RHODE ISLAND RESOURCE RECOVERY CORPORATION
 CENTRAL LANDFILL
 JOHNSTON, RHODE ISLAND

WETLAND PERMIT MODIFICATION

RIDEM FRESH WATER WETLAND APPLICATION MODIFICATION RESTORED CONDITIONS GCC SITE

RIDEM FRESH WATER WETLAND APPLICATION REQUEST FOR PRELIMINARY DETERMINATION LANDFILL GAS TO ENERGY EXPANSION PROJECT

RIDEM FRESH WATER WETLAND APPLICATION
 PROPOSED CONDITIONS GAS CONDITIONING PLANT

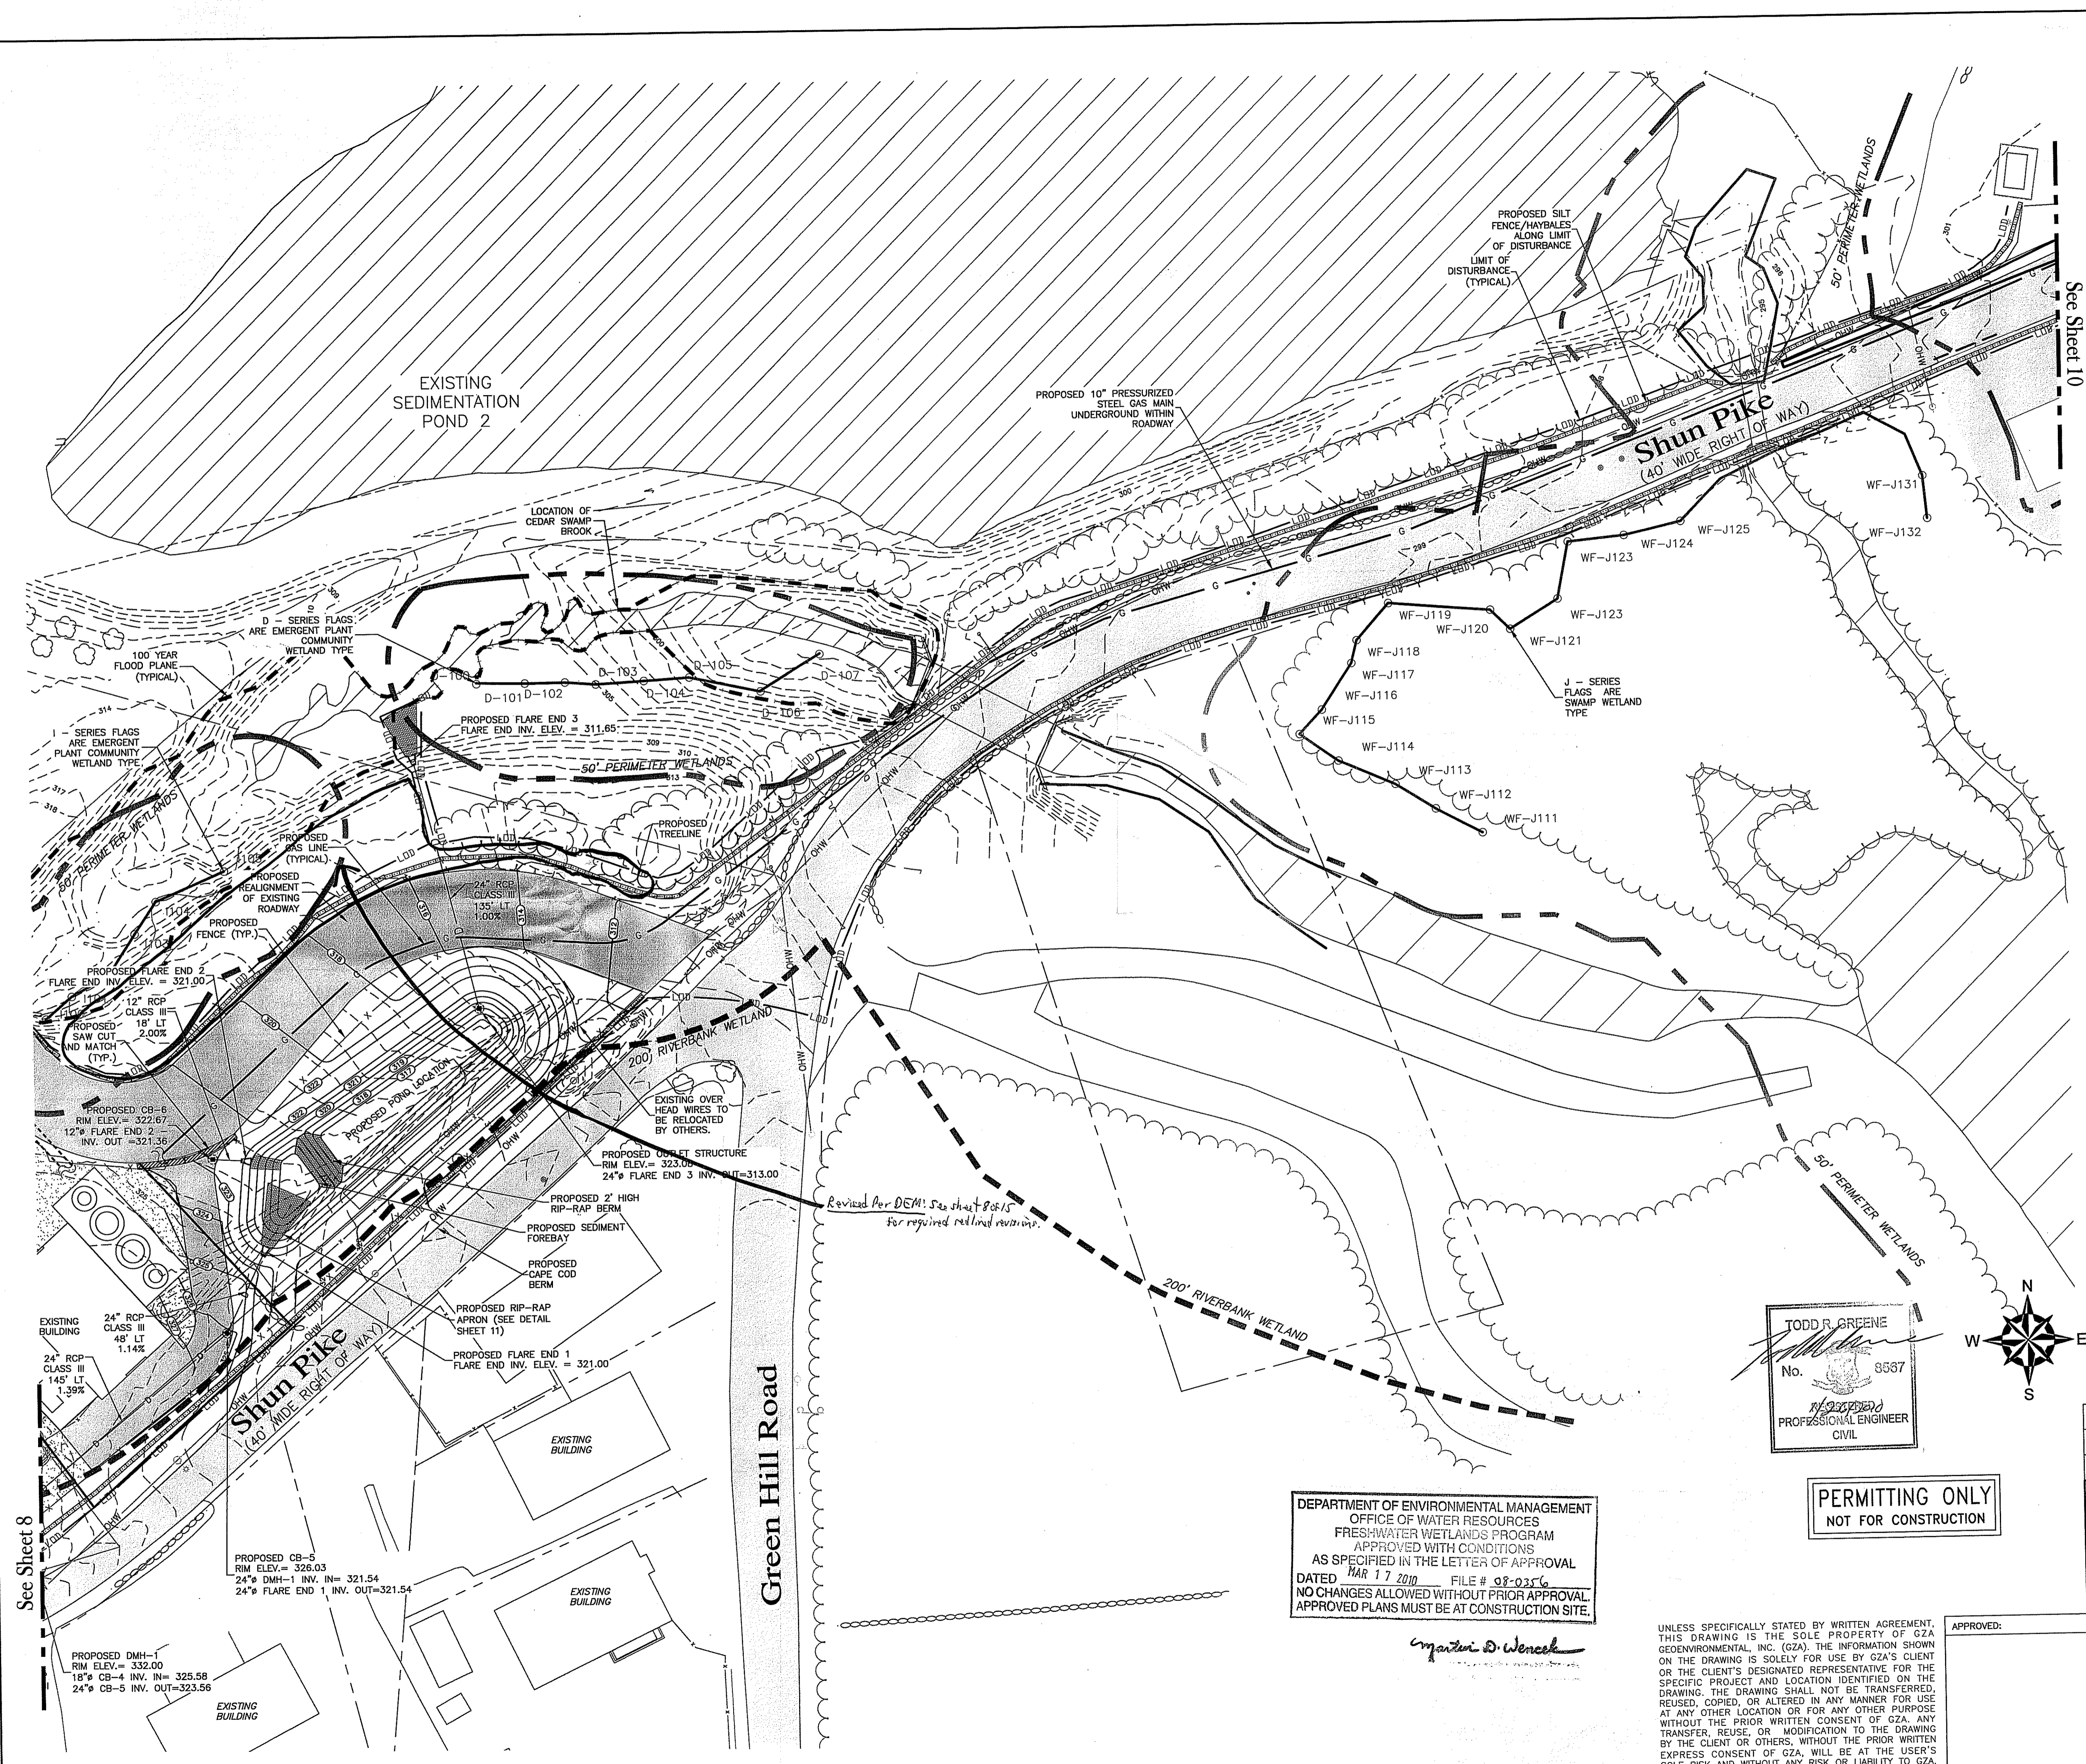
PROPOSED AREA TO BE ENHANCED
 Revised Per DEM: Install a mixture of Lowbush blueberry (*Vaccinium angustifolium*), Highbush blueberry (*Vaccinium corymbosum*), Northern Bayberry (*Myrica pensylvanica*), and Common Blackberry (*Rubus allegheniensis*) shrubs at least three (3) feet in height in rows of three among the existing woody stems (saplings/shrubs). Groups must be no farther than fifteen (15) feet apart.

Per DEM: Install a row of Eastern Red Cedar (*Juniperus virginiana*) saplings here along the limit of disturbance (LOD). Saplings must be at least five (5) feet in height and planted eight (8) feet apart.

Revised Per DEM: Install a row of Eastern Red Cedar (*Juniperus virginiana*) saplings here along the limit of disturbance (LOD). Saplings must be at least five (5) feet in height and planted eight (8) feet apart.

- LOD — LIMIT OF DISTURBANCE
- G — PROPOSED GRADING
- ⊙ — PROPOSED CATCH BASIN
- ⊕ — PROPOSED DOUBLE BASIN
- ⊖ — PROPOSED DRAINAGE MANHOLE
- ⊔ — PROPOSED FLARE END
- G — PROPOSED GAS LINE UNDERGROUND WITHIN ROADWAY
- — — — — EXISTING TREE LINE
- — — — — PROPOSED TREE LINE
- — — — — EXISTING CONTOURS
- — — — — EXISTING STREAM
- E103 E104 E105 — — — — — FLAGGED WETLAND LINE
- — — — — EXISTING OVERHEAD WIRES
- — — — — PROPOSED RIP—RAP APRON
- — — — — 200' RIVERBANK WETLAND
- — — — — 50' PERIMETER WETLAND
- ⊙ (Revised for DEM, see sheet 8 & 11 of 15) — — — — — PROPOSED EVERGREEN TREES
- — — — — — EXISTING GRAVEL AREA
- — — — — EXISTING ABUTTER LINE
- — — — — EXISTING FENCE
- — — — — PROPOSED FENCE
- — — — — EXISTING WALLS
- — — — — — EXISTING PAVED AREA
- — — — — APPROXIMATE 100-YEAR FLOOD PLANE
- ⊔ (Revised for DEM, see sheet 8 & 11 of 15) — — — — — WETLAND AREA TO BE ENHANCED

WETLAND AREA RESTORATION DETAILS AND CONSTRUCTION NOTES

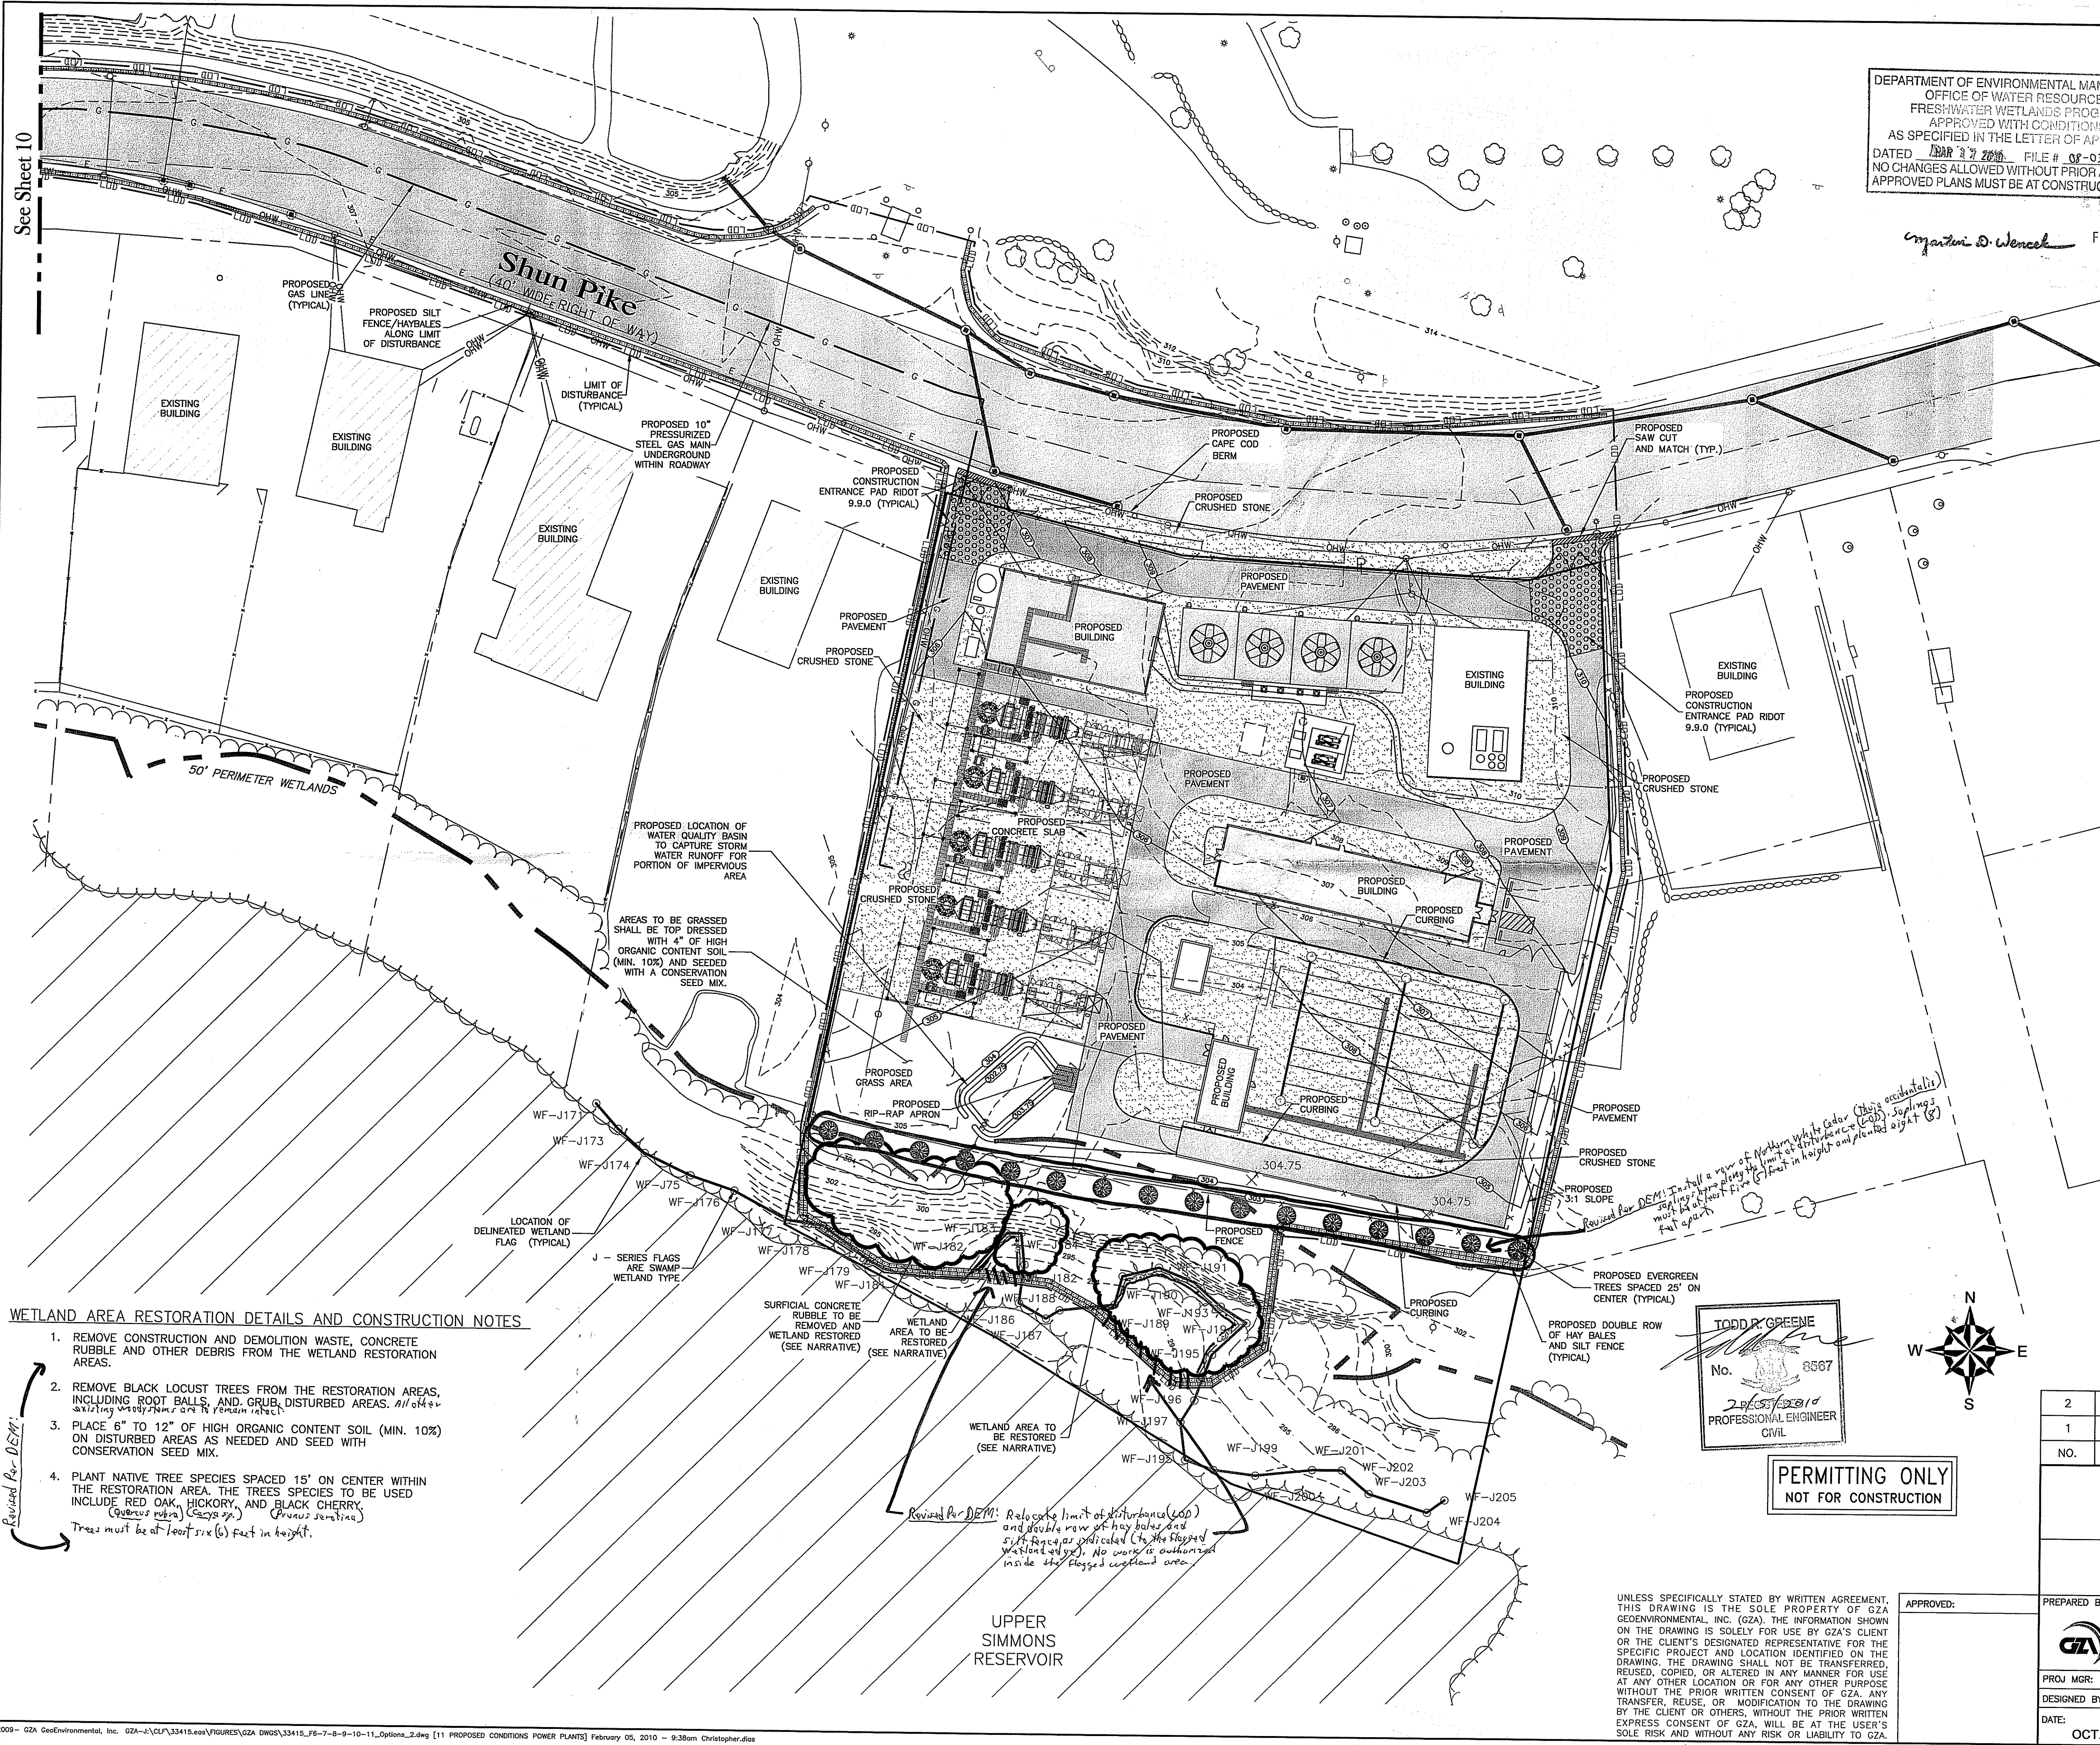
Revised Per DEM:

Revised Per DEM: Relocate limit of disturbance (LOD) and double row of hay bales and silt fence as indicated (to the flagged wetland area). No work is authorized inside the flagged wetland area.
